Our Case Number: ABP-313136-22

Planning Authority Reference Number: SD21A/0161

Re: Two-storey commercial building providing two units and ancillary accommodation, all associated site works.
Lucan Shopping Centre, Newcastle Road, Co. Dublin

Planning application reference number SD21A/0161

Figure 6 Noise modelling for a typical delivery vehicle

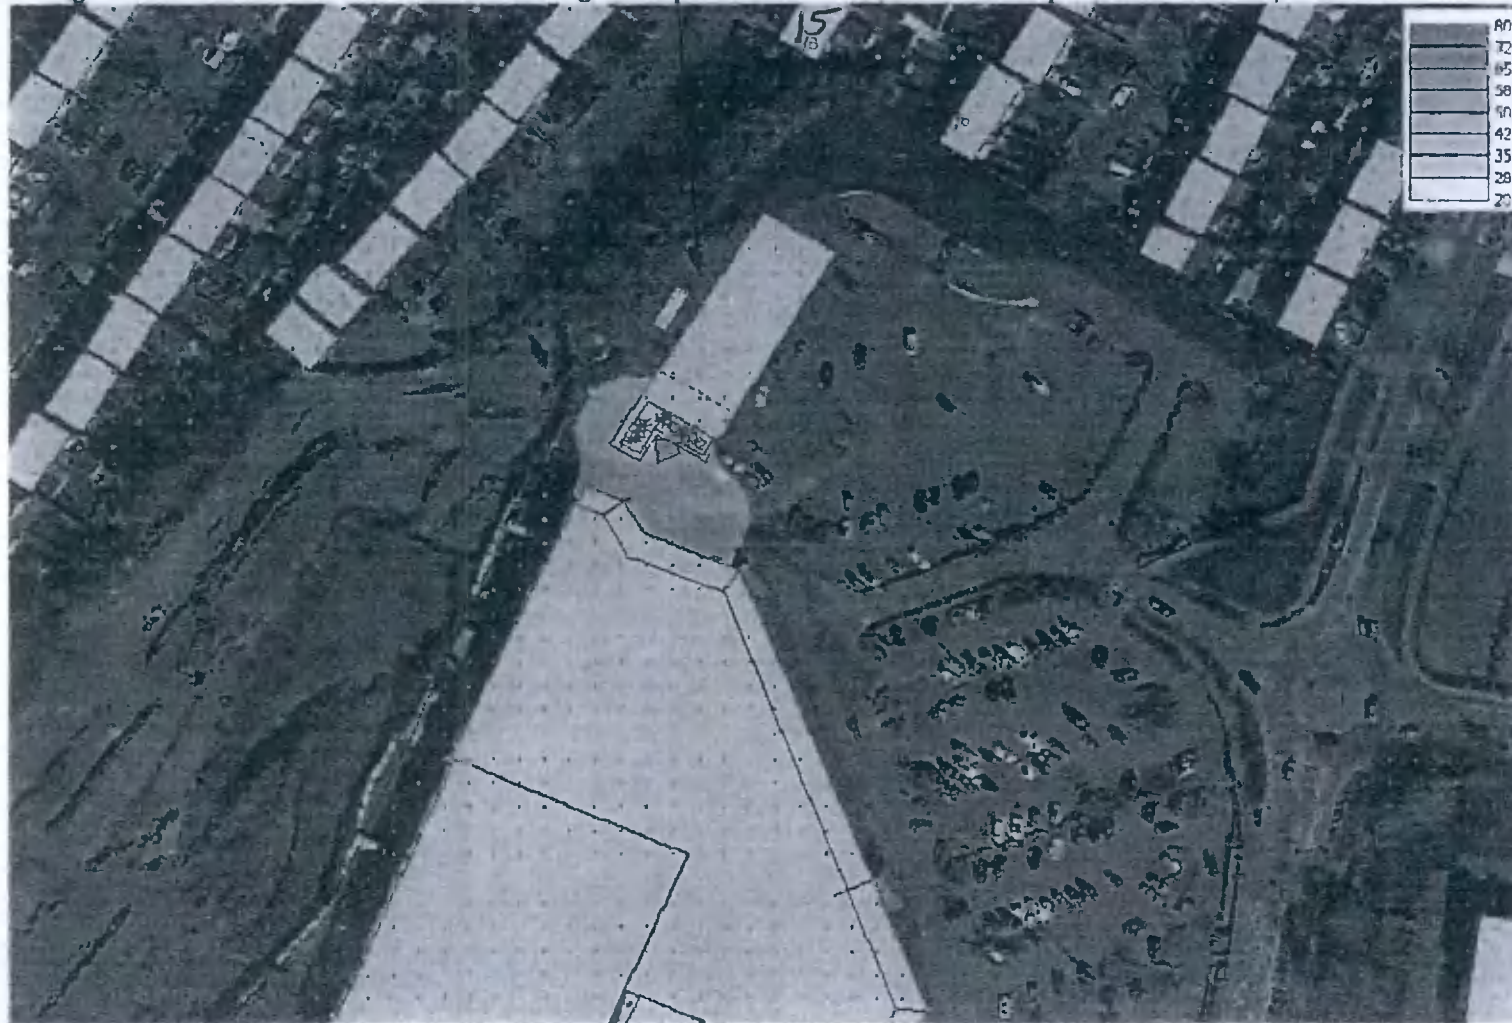
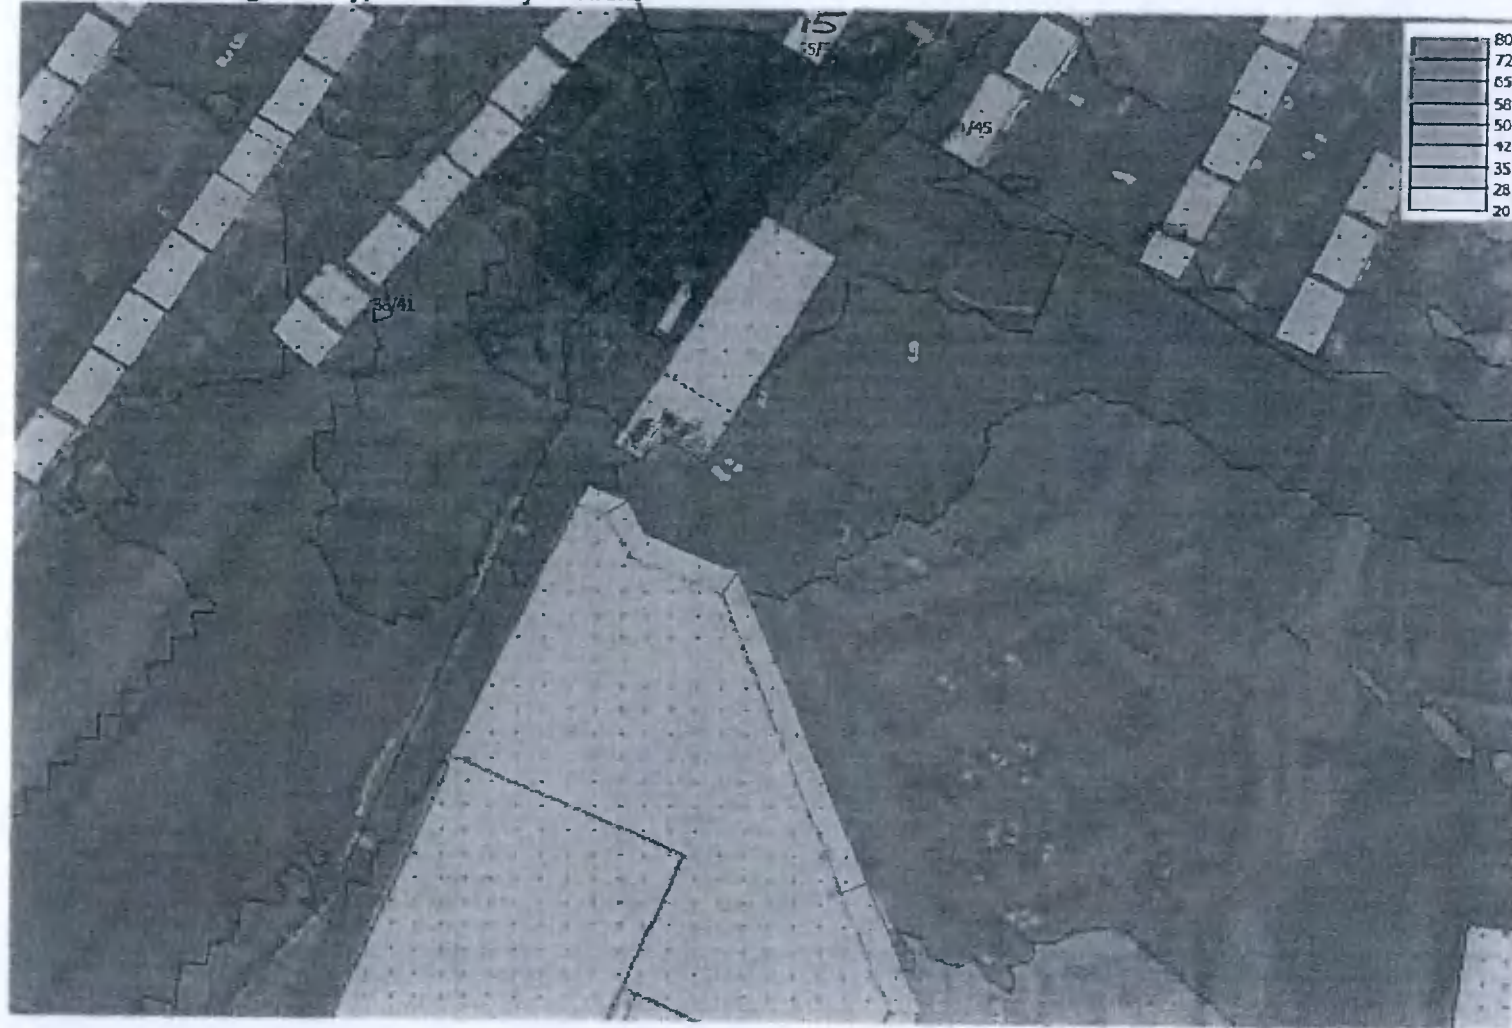
Attached location of 15 Hillcrest Grove on page 11 and 12 of Acoustic Designs. This shows how noise will clearly devalue the property and enjoyment of 15 Hillcrest Grove.

"The Environmental Health Department requested an acoustic report to assess the potential noise impact in more detail. The acoustic report submitted by Acoustic Designs predicts the noise level during vehicles deliveries to be 58.9dB. This is approximately 11dB above the measured daytime background noise level and 25dB above the night time level. This represents a significant increase to noise levels during both day and night time and is very likely to result in complaints being generated. The characteristics of truck noise which includes beeping when reversing further exacerbates the impact of this noise"

Figure 5 Night time noise contours from modelling of the roof mounted plant for the proposed development

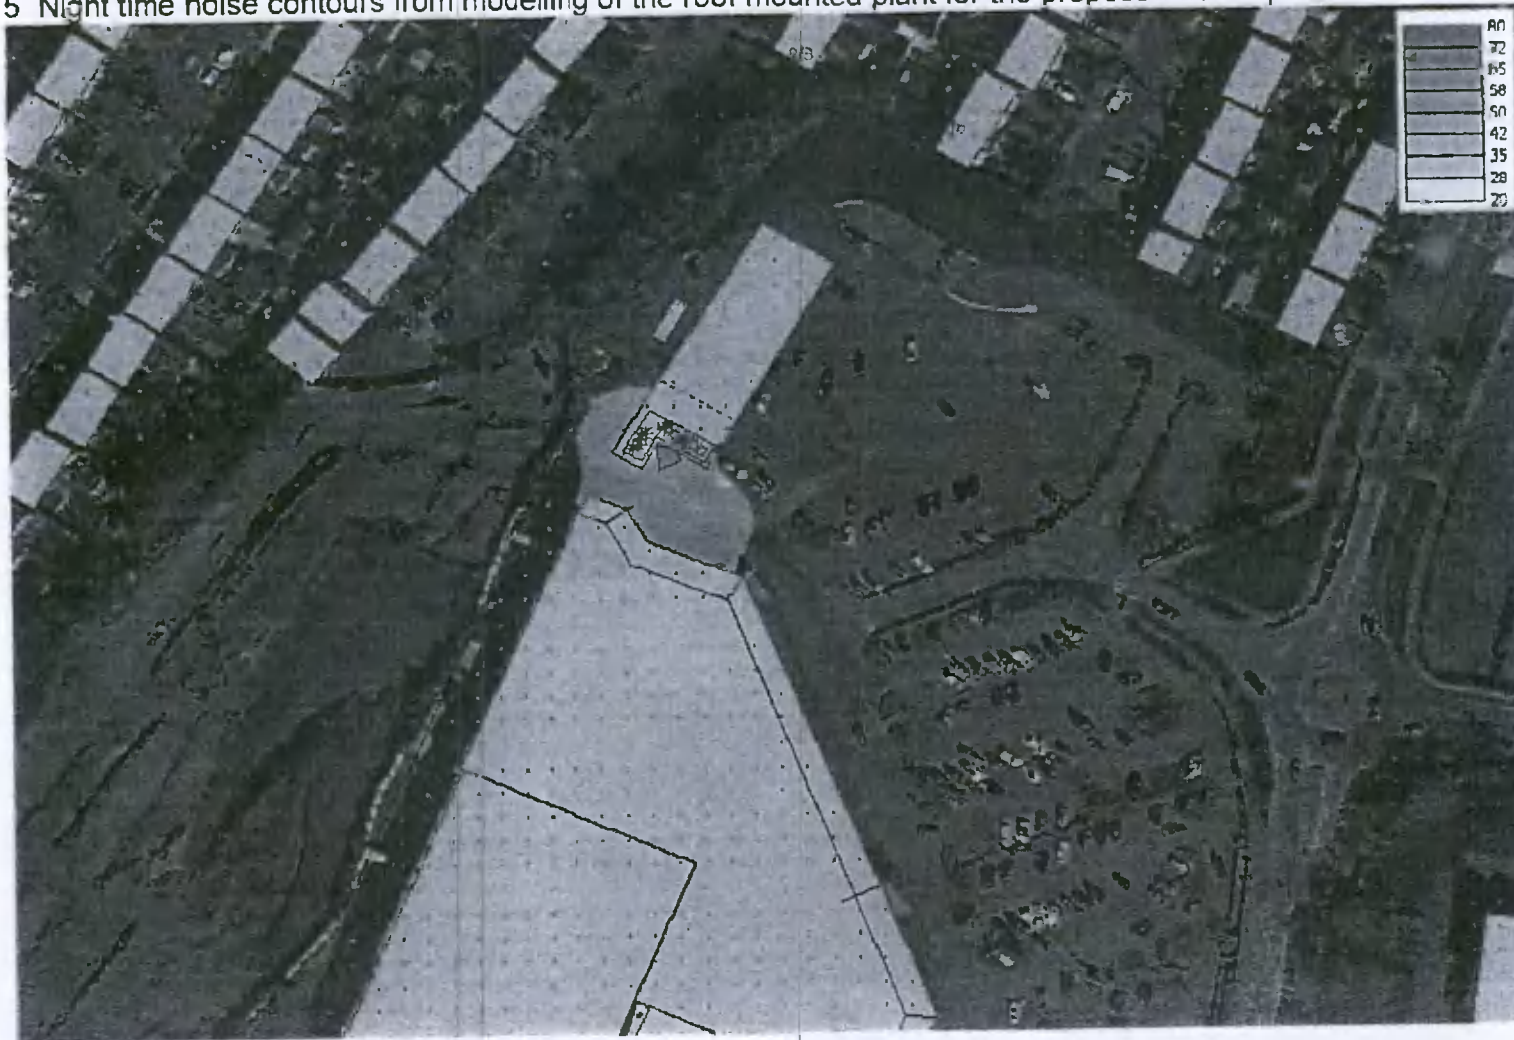
I note what appears to be fans on top of the proposed development this would be unacceptable to residents in Hillcrest Grove.
